Re: Site Plan Revisions
407-419 Mapleview Drive West
City of Barrie, County of Simcoe

Modifications proposed within Site Plan (dated January 5, 2022)

CONCEPTUAL SITE PLAN - 46 Units

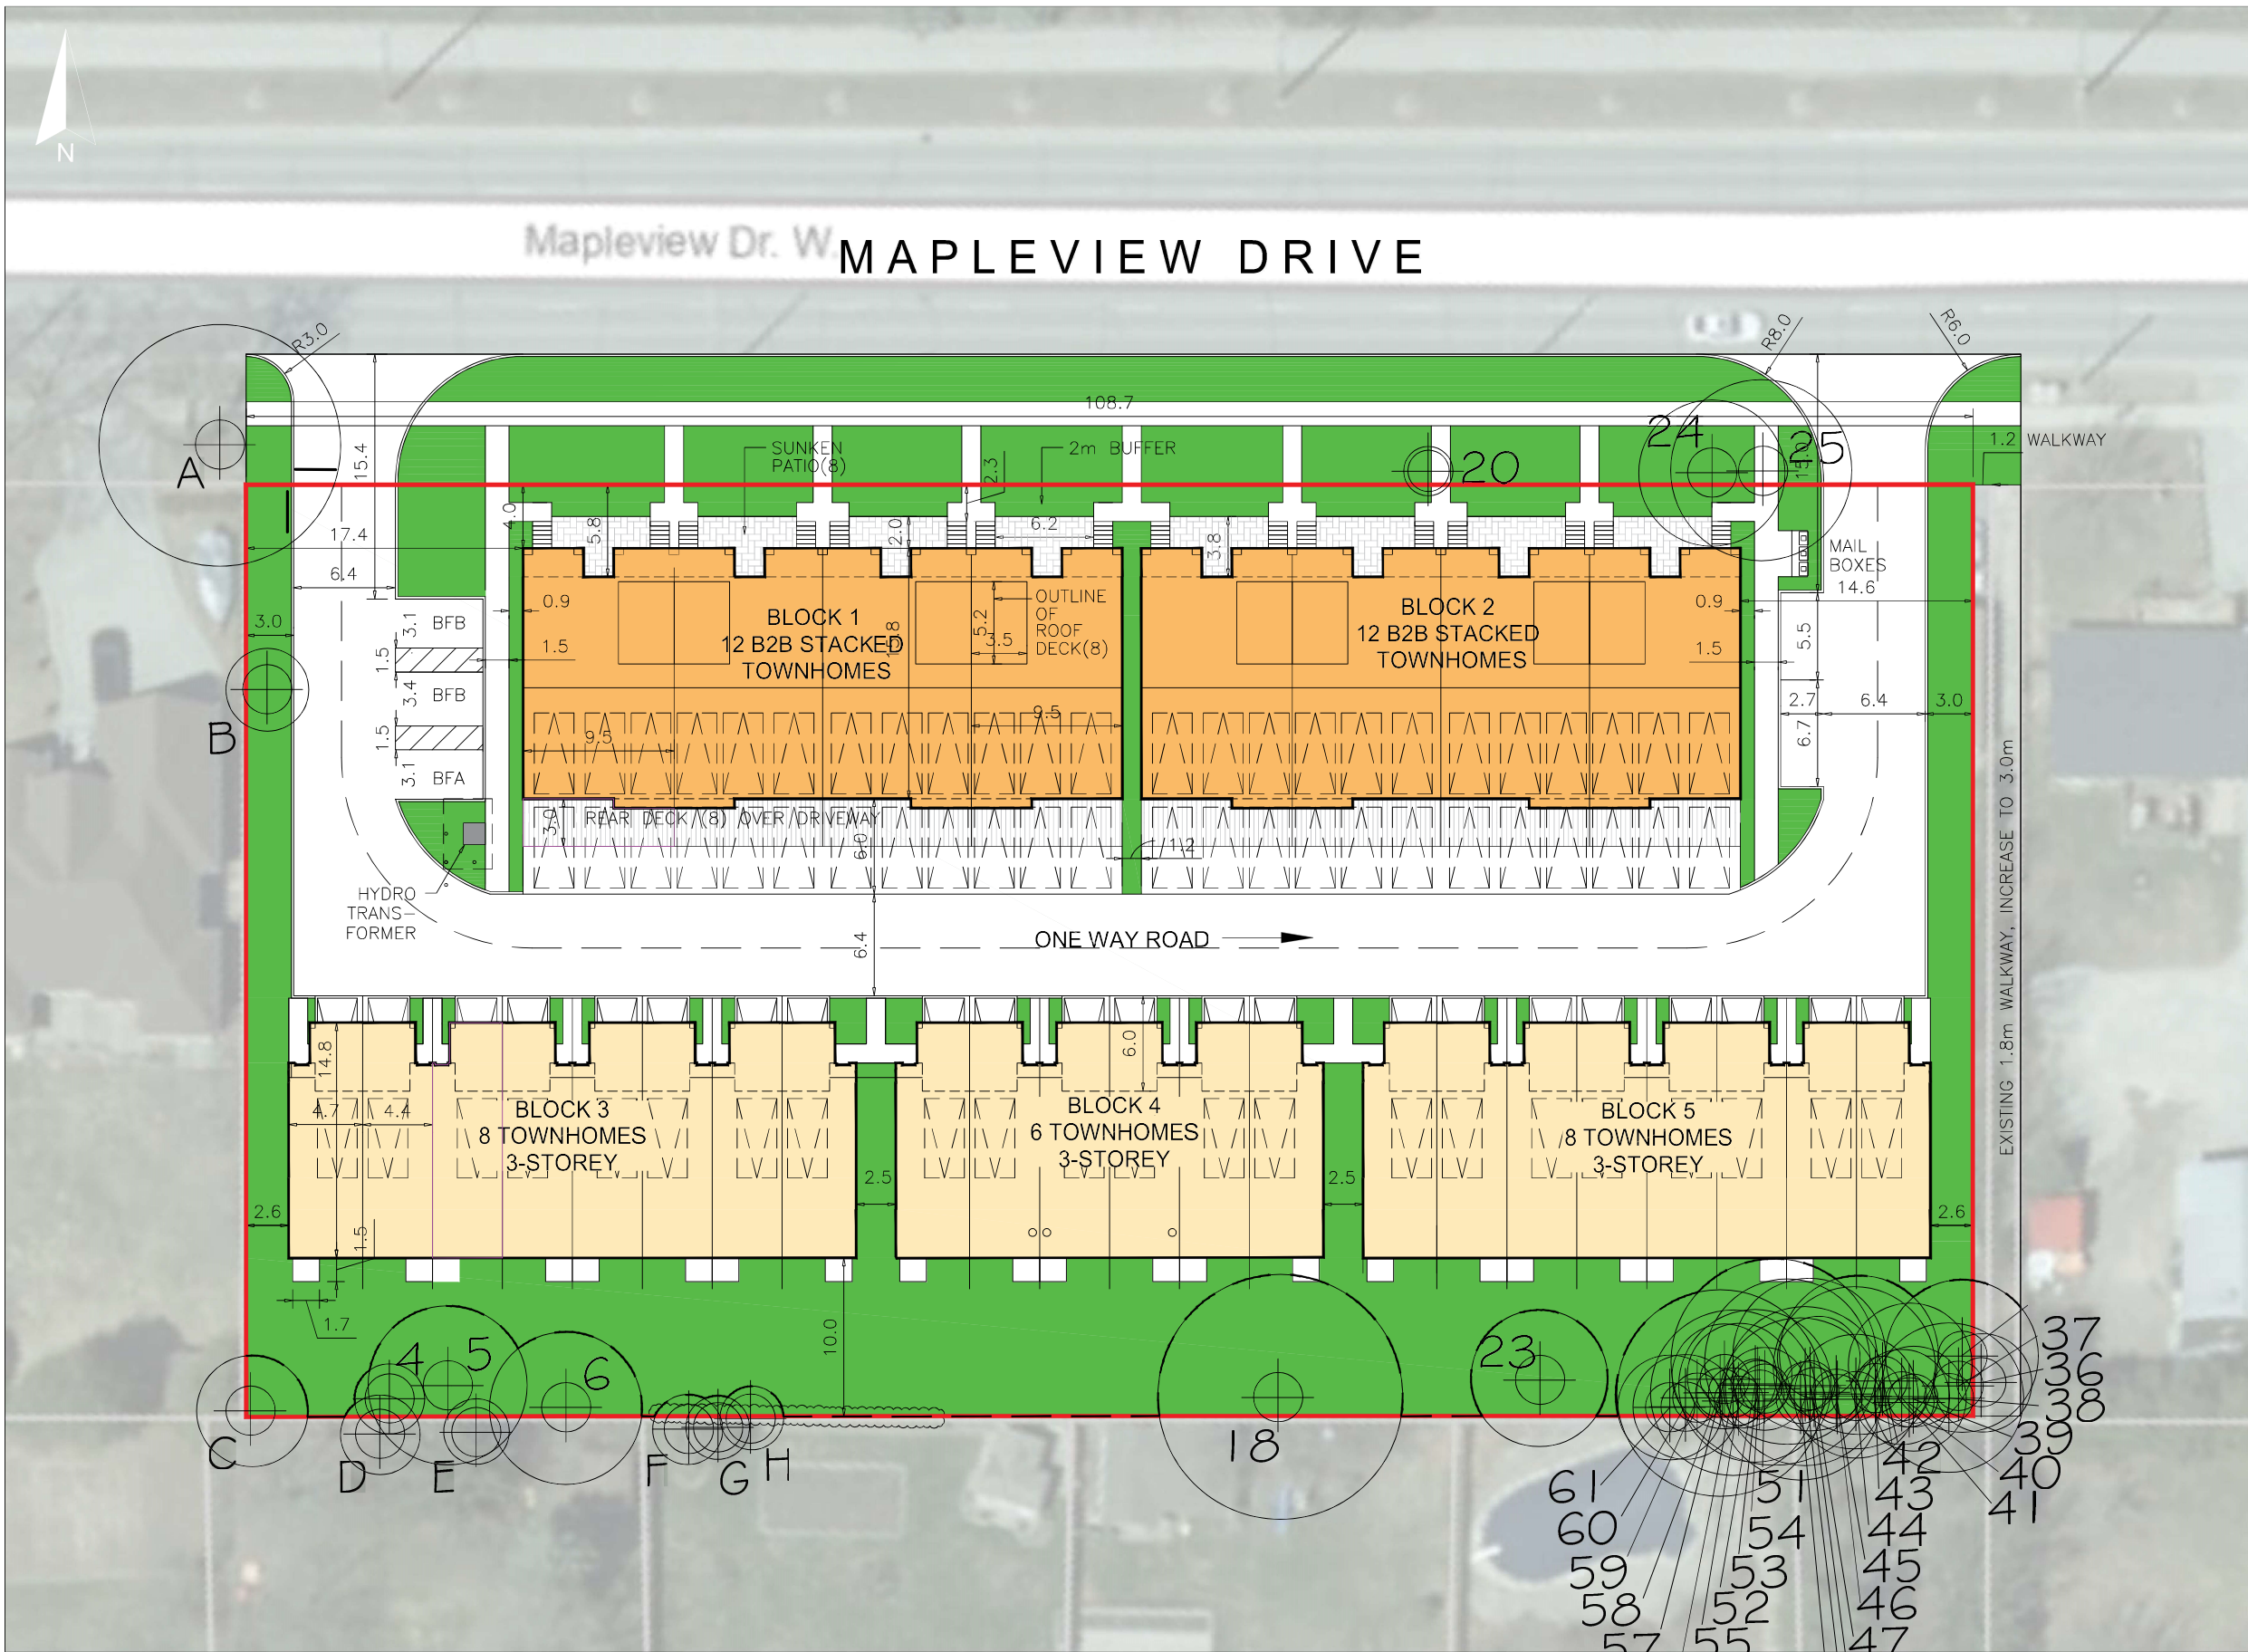
- 1. Eliminate Second Driveway Space for stacked townhouses** – the stacked townhouse driveway length has been reduced from 11.0m to 6.0m for units fronting Mapleview Drive. Rather than providing 2 driveway parking spaces, 1 driveway parking space is now provided for these units. This revision allows for the rear yard setback for the traditional townhouse units backing onto Redfern residents to be increased well above the requirements in the Zoning Bylaw. The removal of the parking space also provides the opportunity to increase the size of the traditional

2. **Rear Yard Setback** – the proposed rear yard setback has been increased from 7.0m to 10.0m. According to our professional arborist, this 10 metre setback provides sufficient space to protect rear yard tree's and increase privacy for Redfern residents.

3. **Rear Yard Decks on Traditional Townhouse Units** – for the traditional townhouse units, the proposed Zoning Bylaw Amendment text has been updated to include, "a maximum second storey rear yard deck area of 2.55m² (1.5mx1.7m) along with a minimum rear yard setback of 8.5 metres, per traditional townhouse (Blocks 3, 4, 5)". This provision ensures that the traditional townhouse decks are limited in size restricting the potential use of this space, further ensuring privacy for Redfern residents is maintained.

5. **Traditional Townhouse Unit Size/Depth** – the depth of the traditional townhouse units has slightly increased, providing townhouses that are now approximately 1,850 square feet.

6. **Stacked townhouse decks reduced** – due to the change in driveway length noted in item #1 above, the decks over the parking area have been reduced. They are now approximately 28.5 square metres per unit. The zoning requirement for this outdoor amenity space is 12 square metres per unit.

SCHEDULE OF REVISIONS			
No.	Date	Description	By
1	Sept 15, 2021	Create final conceptual plan	J.V.
2	Sept 30, 2021	Issued for review	J.V.
3	Oct 7, 2021	Revisions based on comments	J.V.
4	Jan 5, 2022	Increase rear yard depth by revising driveway length of Back-to-Back towns;	A.S.
